Request	-	Special Use Permit for Modifications to Major Utility
Location	-	3900 N Summit Street
Applicant + Owner	-	City of Toledo 1 Government Center Suite 2250 Toledo, OH 43604
Engineer	-	Jones & Henry Engineers, LTD 3101 Executive Pkwy Toledo, OH 43606
Architect	-	Thomas Porter Architects 8 N St. Clair St Toledo, OH 43604

The staff recommends that the Toledo City Plan Commission recommend approval of SUP-7004-23, Special Use Permit for Modifications to Major Utility at 3900 Summit Street to the Toledo City Council for the following two (2) reasons:

SPECIAL USE PERMIT  
TOLEDO CITY PLAN COMMISSION  
REF: SUP-7004-23  
DATE: September 14, 2023  
TIME: 2:00 P.M.

SITE PLAN

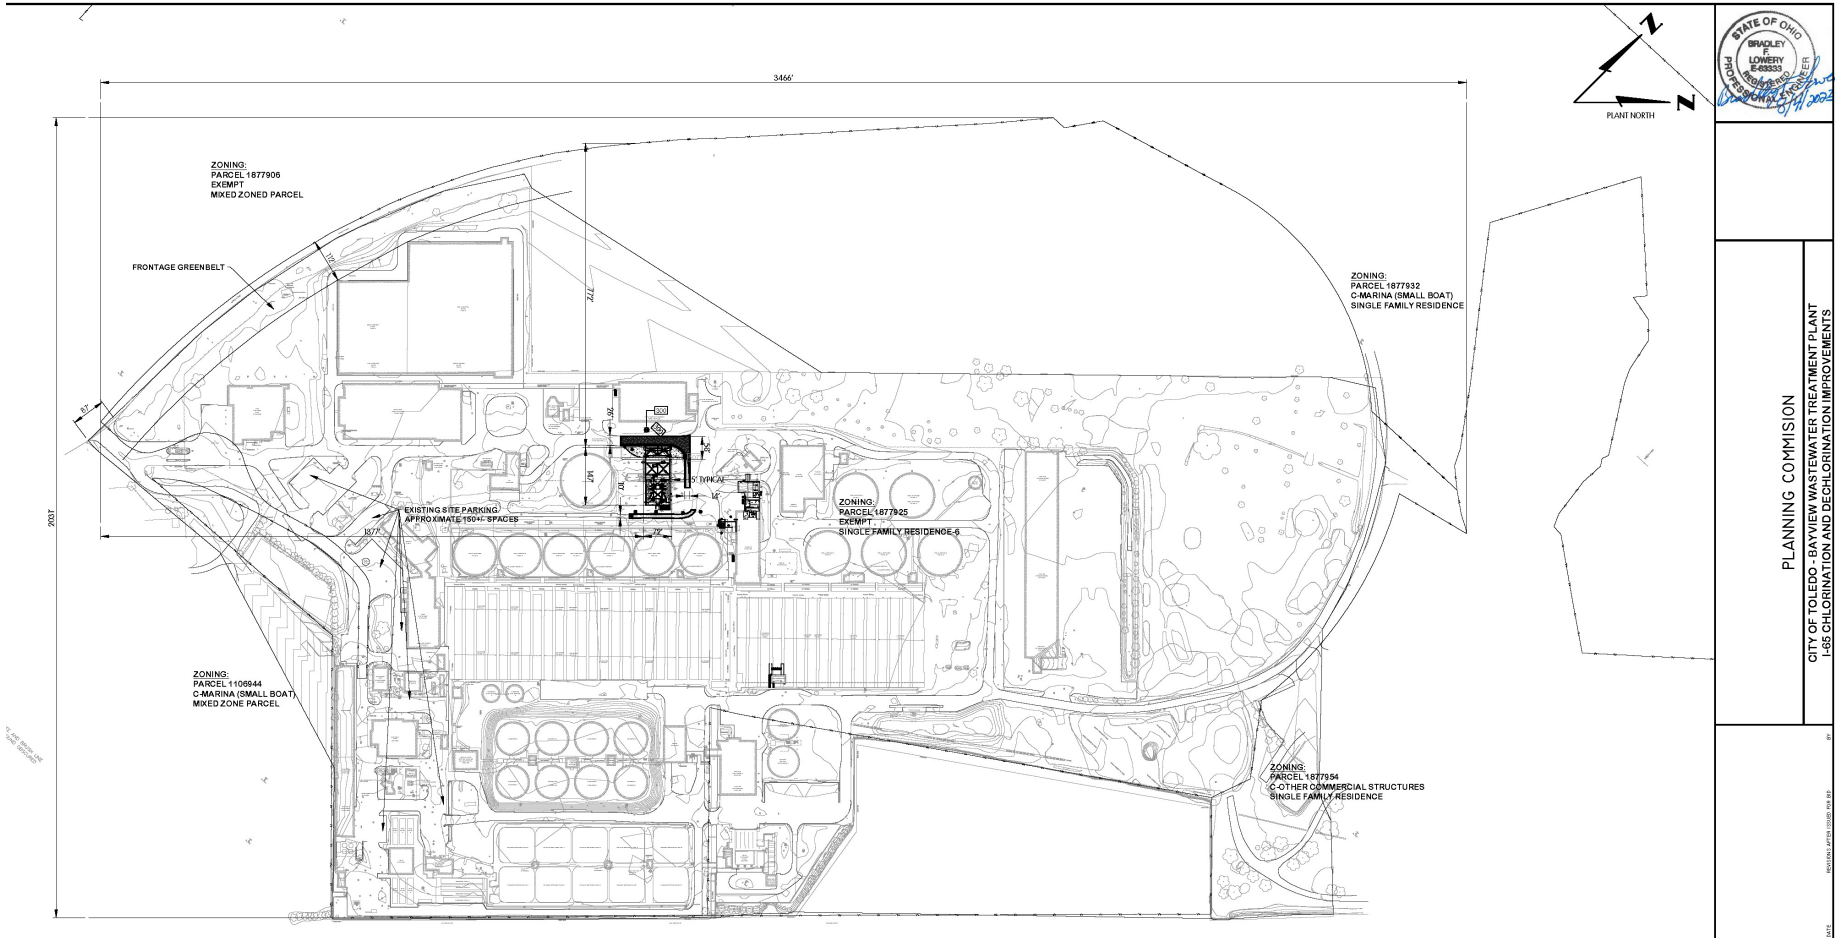
20. Existing parking shall adhere to the standards of TMC§1107.1700 – Accessible parking for physically disabled persons. **A revised site plan shall list the total quantity of accessible van and car spaces.**

23. Off-street parking and loading spaces, parking lots, maneuvering areas, aisles and driveways must be surfaced with concrete, bituminous asphalt, or other dust-free material other than gravel or loose fill, and be graded to drain all surface water towards the interior of the parking lot. **Acceptable as depicted on site plan.**

- a. Four (4) additional two-inch caliper trees are required per TMC§1108.0205. **Not acceptable as depicted.**
  - b. The location, height and materials for any new and existing fencing to be maintained. Per TMC 1108.0203(H), the fencing shall be at least 6 feet high, but not higher than 10 feet and may be shadow box, chain link with slats, stockade, or another type approved by the Plan Commission.

- d. No rip-rap, crushed stone, concrete or other impervious materials may be exposed above the average pool elevation for any retention pond.
  - e. The location, number, height, diameter and species of any materials to be planted and maintained, as well as the location and number of any existing trees to be retained, trees, shrubs, and landscape materials shall meet the standards included in TMC 1108.0400 Landscape Materials Standards. **Shall be submitted on a revised site plan.**

# SITE PLAN - MAGNIFIED

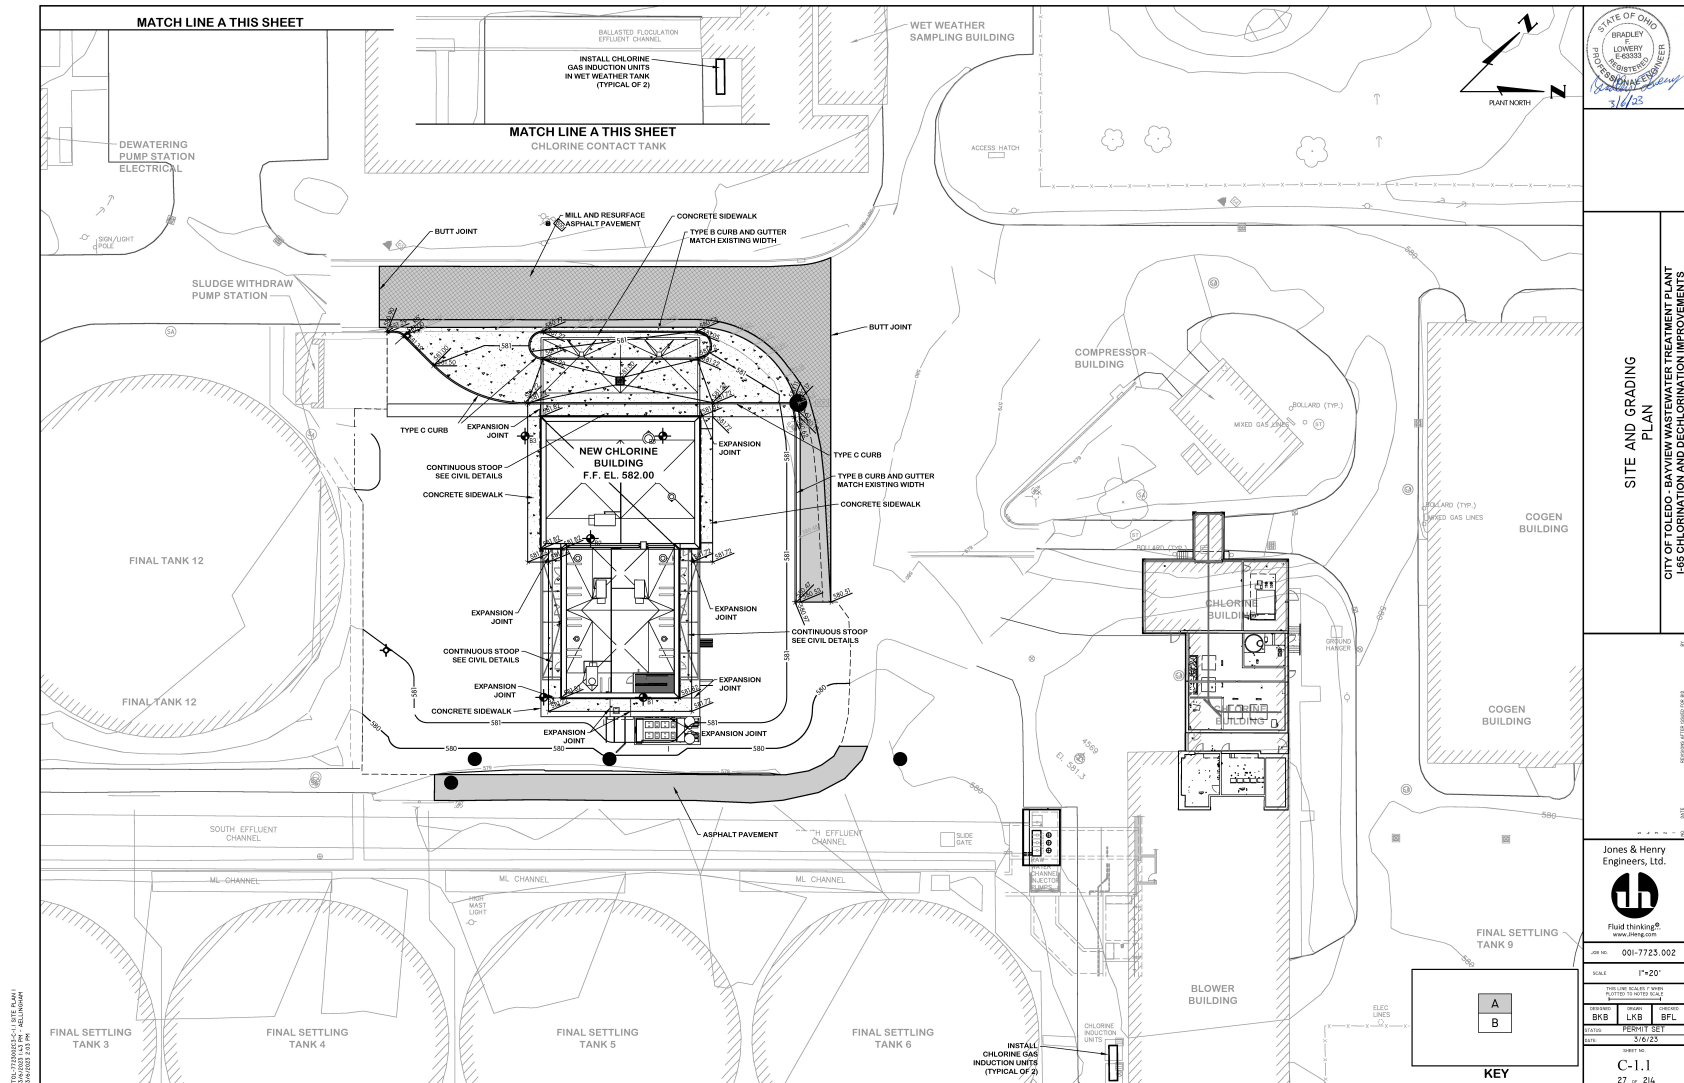
6. Approved Premises identification is required.
7. Key box(s) for access to buildings and areas restricted by fences, gates, etc.
8. Fire apparatus access roads shall have an unobstructed width of not less than 20'. Paved road south east of the new building from where it leaves the main paved area to its dead end.

9. Fire apparatus access roads shall have an unobstructed vertical clearance of not less than 13'6".
10. Dead end fire apparatus access roads in excess of 150' shall be provided with an approved turn around area. Paved road south east of the new building from where it leaves the main paved area to its dead end.

CHLORINE BUILDING  
ARCHITECTURAL  
EXTERIOR ELEVATIONS  
CITY OF TOLEDO – BAYVIEW WASTEWATER TREATMENT PLANT  
E-65 CHLORINATION AND DECHLORINATION IMPROVEMENTS

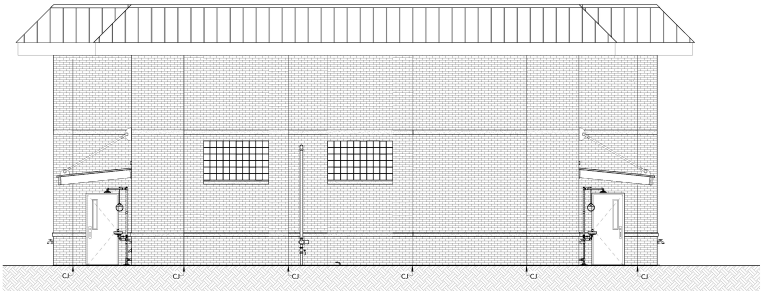
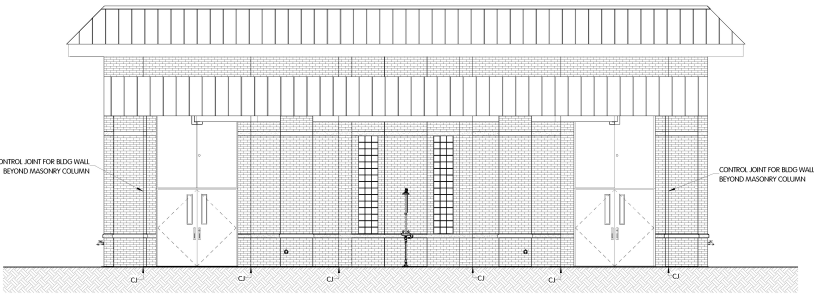
Industrial buildings are required to utilize low-reflectance, subtle, neutral, or earth tone colors per TMC§1109.0402. The proposed chlorination building is a one-story masonry veneer building with glass block windows, fiberglass exterior doors and frames, pre-finished standing seam metal canopies/parapet accents, and a pre-finished flush metal panel clad covered drive approach. The masonry veneer color scheme shall be a red blend and the seam metal copies a blue-finish to match surrounding structures.

25. All structures shall utilize durable building materials such as brick, stone, metal, or concrete. **Proposed materials on chlorination building area acceptable as depicted.**
